COMPLETE MONOGRAPH

2021 GROUP A PROPOSED CHANGES TO THE I-CODES

April 11 – May 5, 2021
Virtual Committee Action Hearings

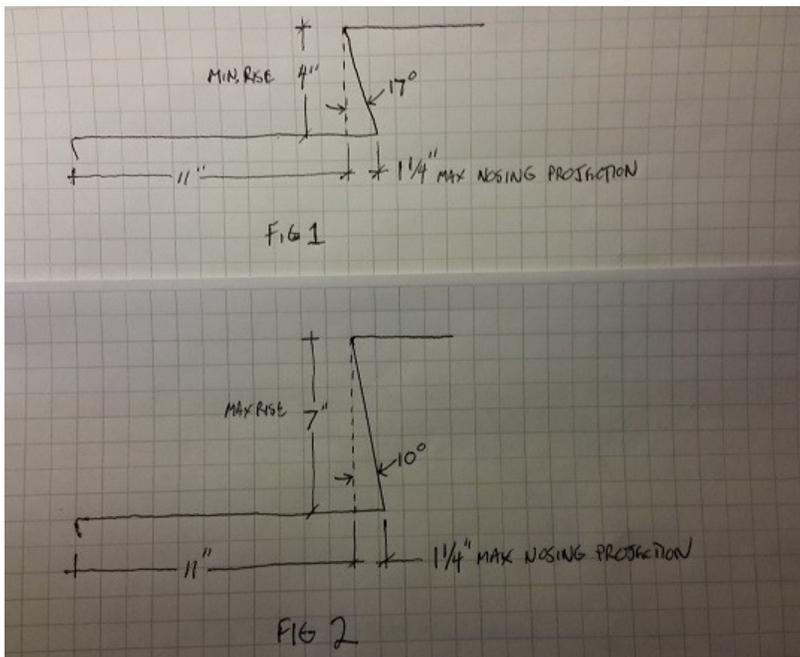
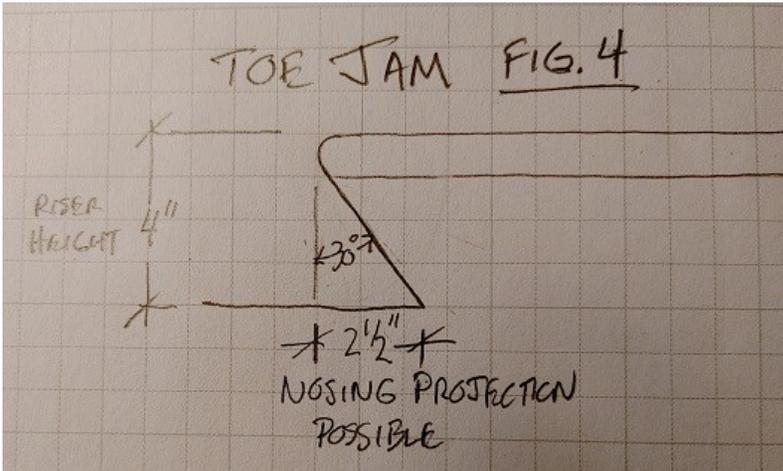
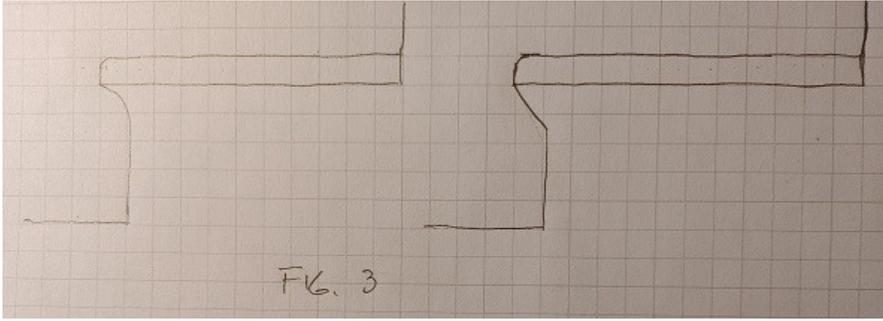
Reason Statement: In the previous cycle we sought to eliminate the 30 degree maximum riser slope as misleading because the limit of the slope would be controlled by the limit of the nosing projection (see figures 1 & 2). The committee pointed out the possibility that the riser face could be "faceted" a combination of angles or curved in compliance with the allowed nosing projection and that the limit was necessary. (see figure 3). Complicating this is that the text clearly states the slope of the riser starts "under the tread above" but some of the committee discussion clearly confused the nosing to be part of the riser.

Left unchanged this requirement will continue to be misinterpreted to result in the very unsafe condition it intends to prevent, that of providing an impediment to a foot that might be dragged up the riser face in ascent. When misinterpreted to slope the riser at 30 degrees beyond the allowed nosing projection, a toe wedging hazard is created (see figure 4) that is amplified at lower riser heights. The text added here provides the needed clarification.

1011.5.5.1 Nosing projection size. The leading edge (nosings) of treads shall project not more than $1\frac{1}{4}$ inches (32 mm) beyond the tread below.

1011.5.5.2 Nosing projection uniformity. Nosing projections of the leading edges shall be of uniform size, including the projections of the nosing's leading edge of the floor at the top of a flight.

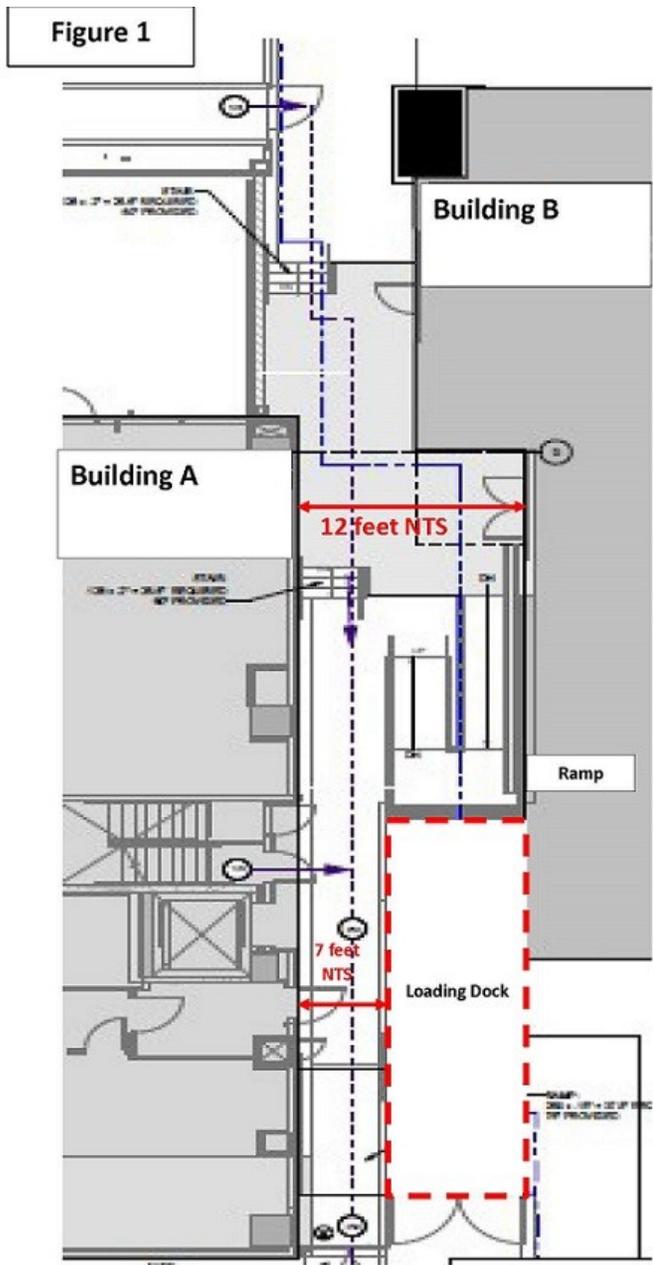
Figure 1 highlights a case where two Type IA fully sprinklered buildings share a common exit court that has a loading dock, stairs and a ramp that

direct occupants from both buildings to walk along the walls of building A. The space between the buildings is 12 feet however the walkway is located within a 7 ft wide portion of it. The IBC intends that this egress court be protected for the benefit of occupants in Building A and B. Without the addition of the exception code users will assume that the exterior wall and openings on building A do not require protection.

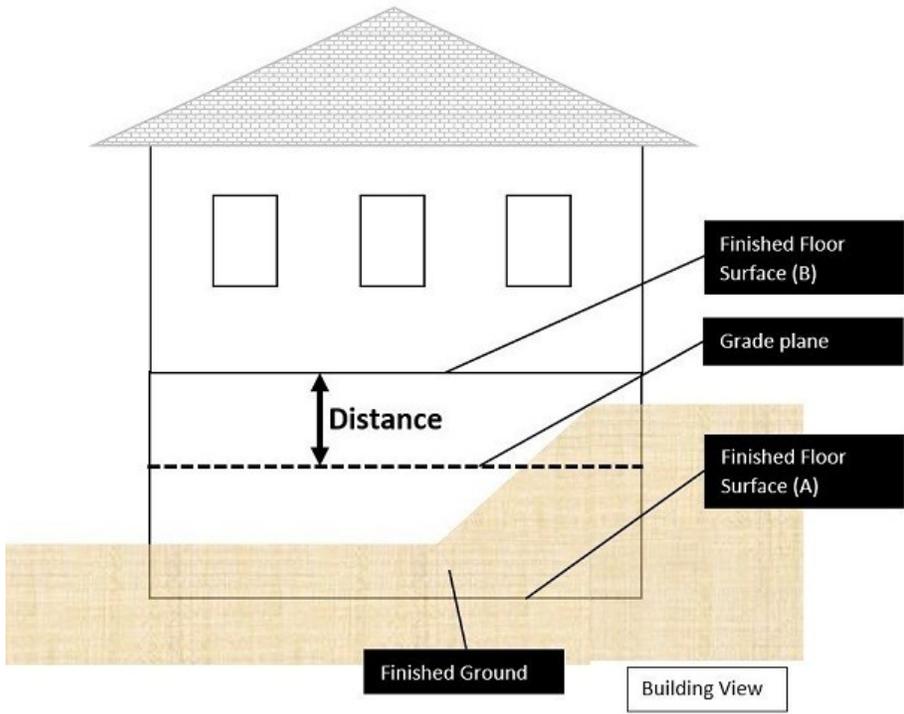
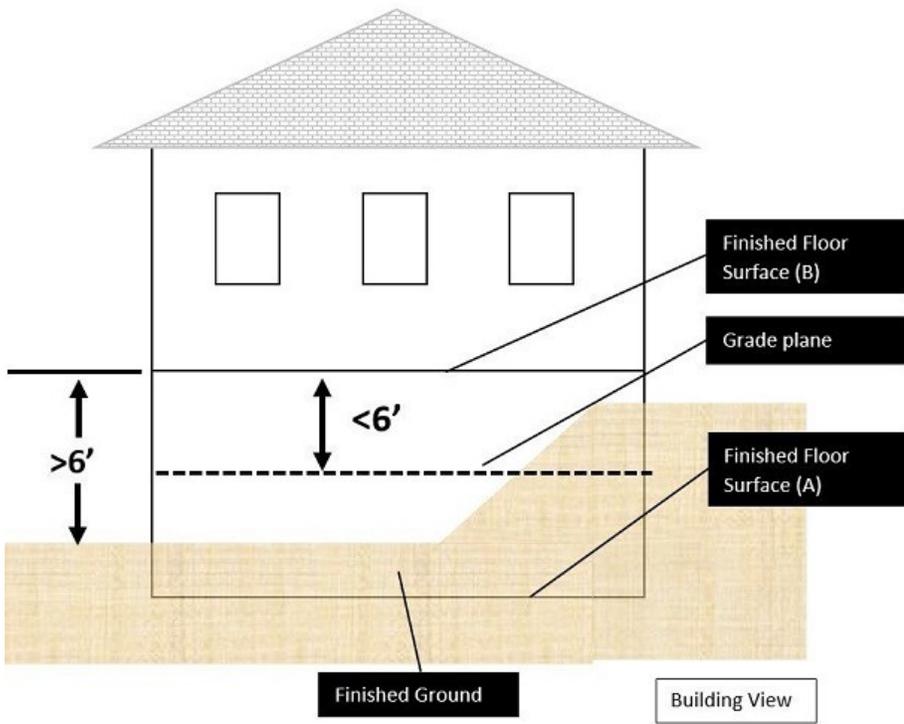
Reason Statement: When the entirety of a finished floor surface is not above *grade plane* the current code provisions describe two different scenarios that will still define it as a *story above grade plane*. The first provision specifies that the finished floor surface will be considered a story above *grade plane* if the finished story next above is more than 6 feet (1829 mm) above *grade plane*, where *grade plane* is defined as a "reference plane representing the average of the finished ground level adjoining the building at all exterior walls." A hypothetical simple example can be imagined with a level finished ground level, which is shown below, that fulfills this requirement.

Not all buildings and dwellings are constructed on level finished ground and can instead be constructed on uneven finished ground as shown below. According to the current code provisions, if the dimension labeled 'distance' is greater than 6' then the finished floor surface (A) corresponds to a *story above grade plane*.

The proposed change to the code applies to the figure below because more than 50 percent of the total building perimeter is more than 6 feet (1829 mm) above the finished ground level. In the figure below the current code provisions would not characterize the finished floor surface (A) as part of a story above grade plane and would instead finished floor surface (B) would apply to the first story above grade plane.

Figure 4. Comparison of Building Heights for Group R-1 and R-2 sprinklered occupancies based on proposed code change.

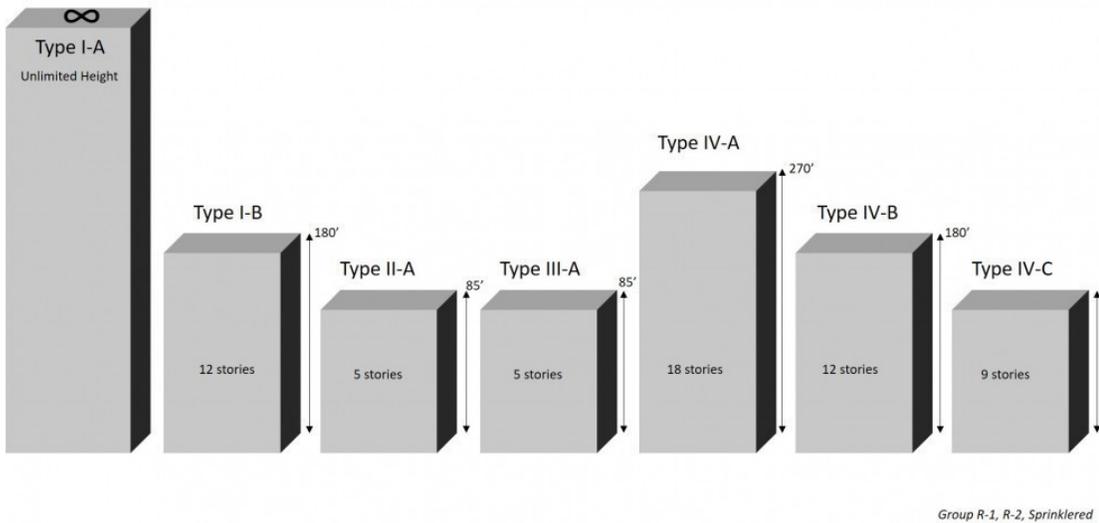
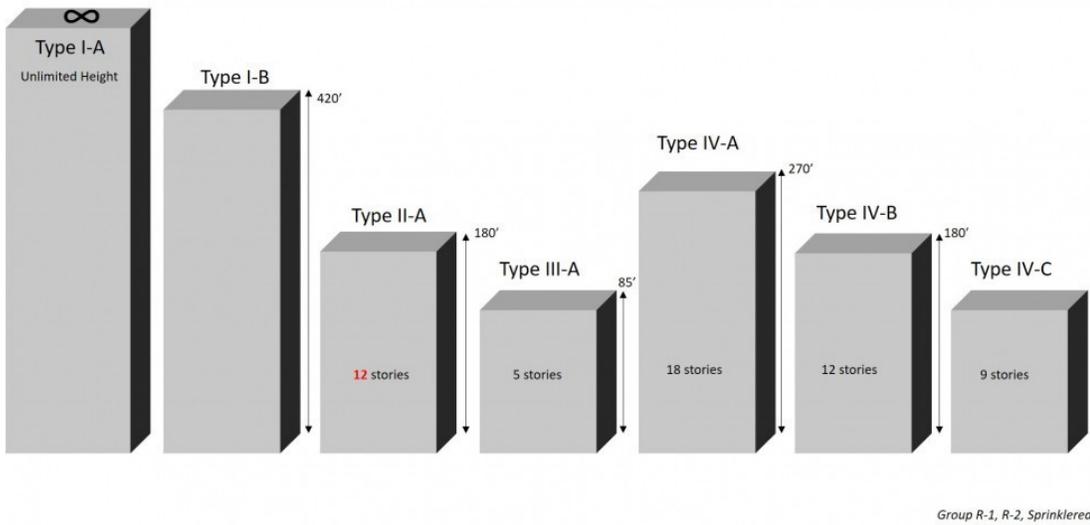
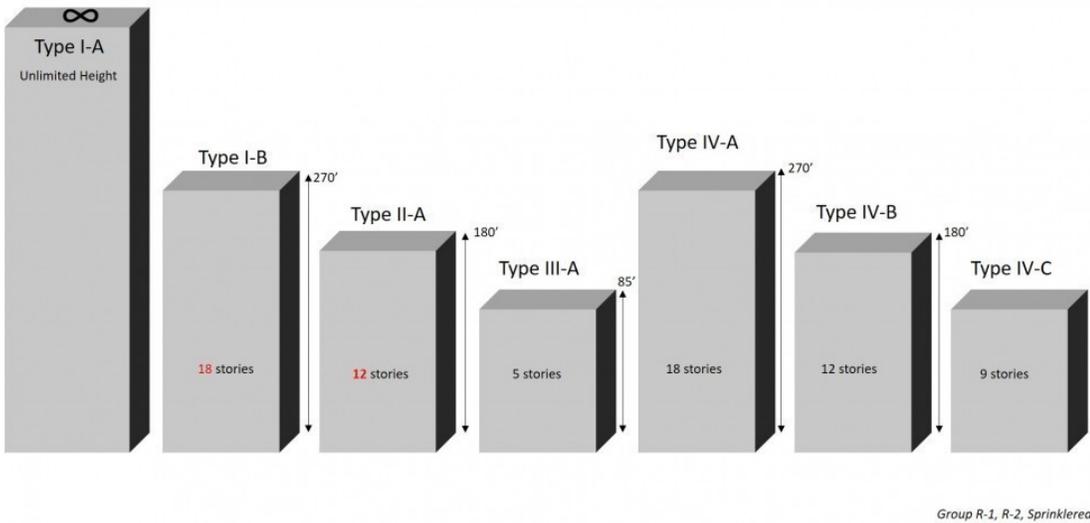
For the same Residential Group R-1 and R-2 buildings protected by automatic sprinklers where exceptions of IBC [2021] Section 403.2.1.1 are applied, this example is modified as shown in Figure 3.

For the proposed code change, Figure 4 illustrates no increases to building height over what is permitted by Section 403.2.1.1, and does not intend to present any decrease in the level of safety from the previous code edition based on the introduction of footnote i.

Figure 503.1 Location of PV Support Structures on Open Parking Structures.

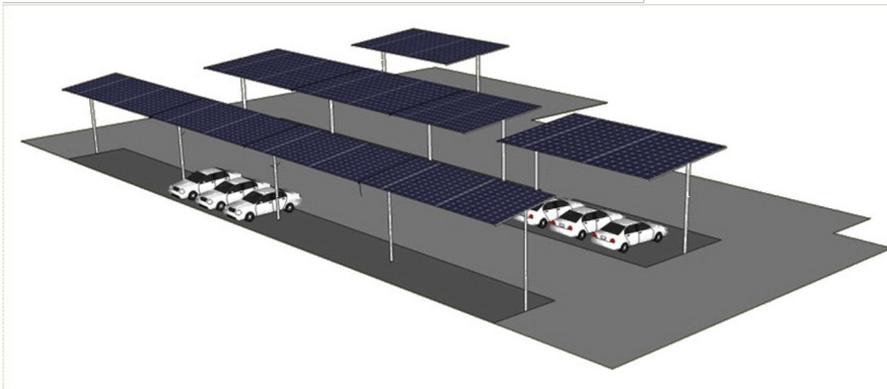
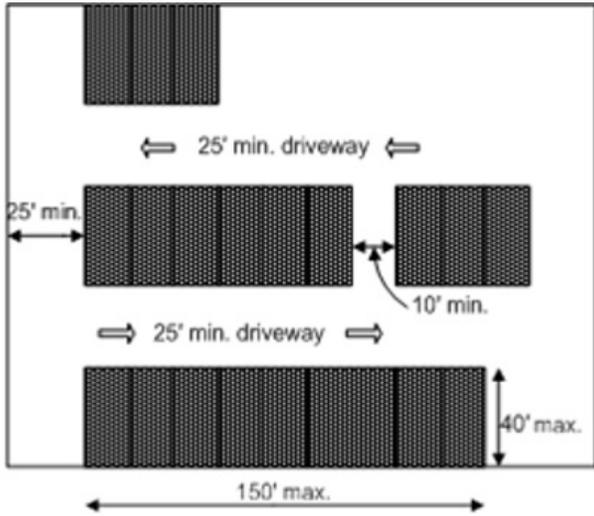
- 1.2.1. 10 feet (3050 mm) above the allowable building height.
 - 1.2.2. 10 feet (3050 mm) above the roof of the building immediately below.
2. Photovoltaic (PV) support structures installed on the roof of an open parking structure shall not constitute an additional story or additional floor area and shall be permitted to exceed the height limit of a building where all the following conditions are met (see Figure 503.1):

FIGURE 3115.3.2
MARKING IDENTIFICATION AND LIKELY LAYOUT

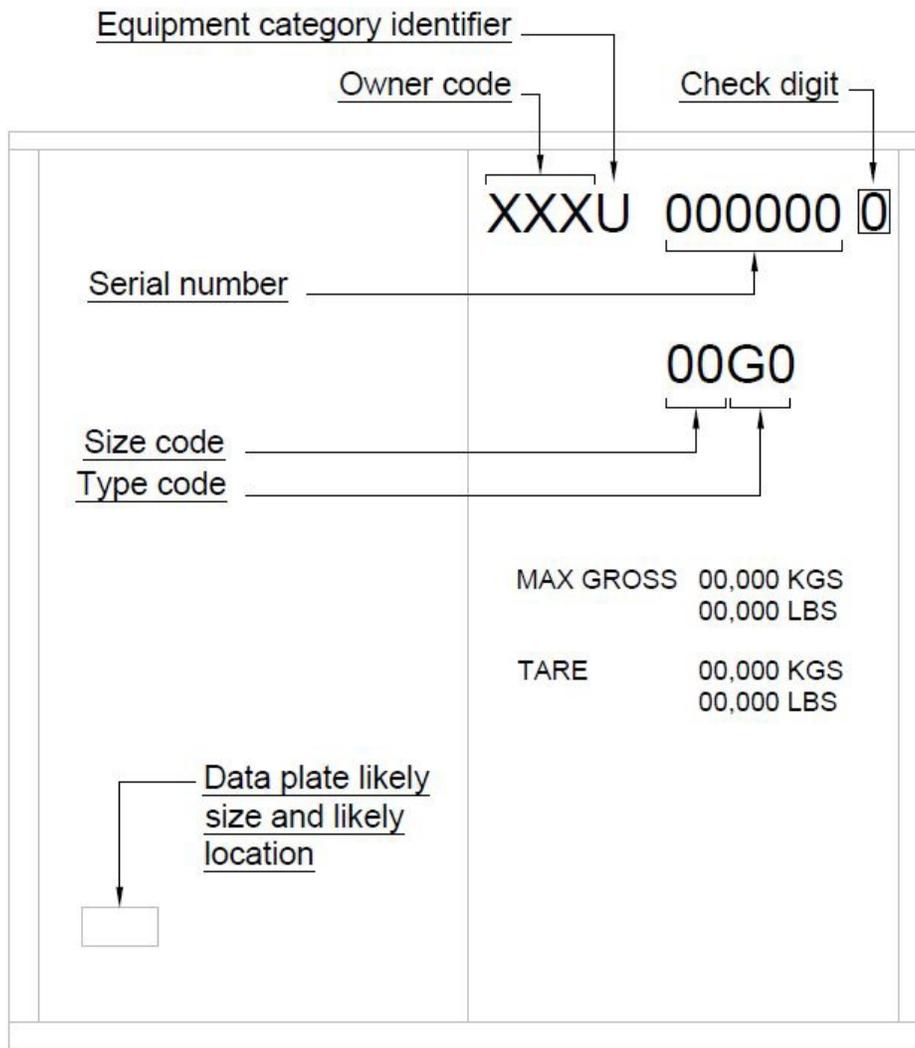
3115.3.2 Intermodal shipping container markings. *Intermodal shipping containers shall have markings, separate from the data plate, containing the following information. Refer to Figure 3115.3.2 for an example layout of the markings.*

**FIGURE 3115.8.3.4
CONTAINER ELEMENT IDENTIFICATION**

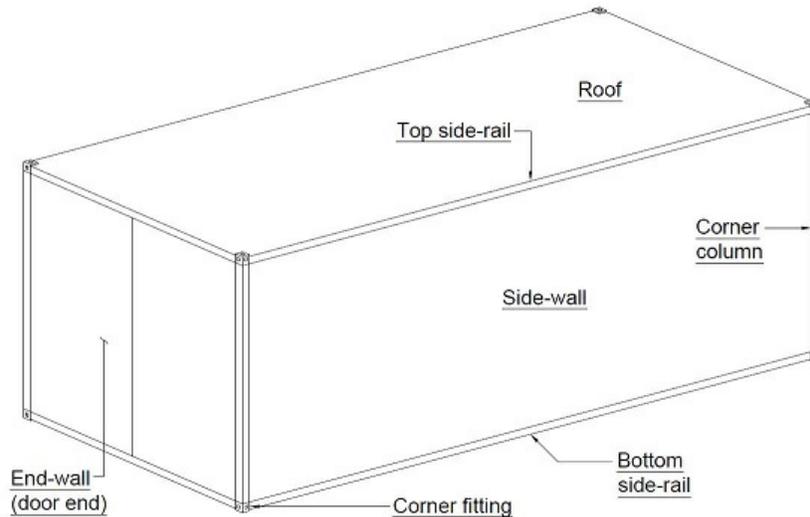
The components names are labeled in Figure 3115.8.3.4.
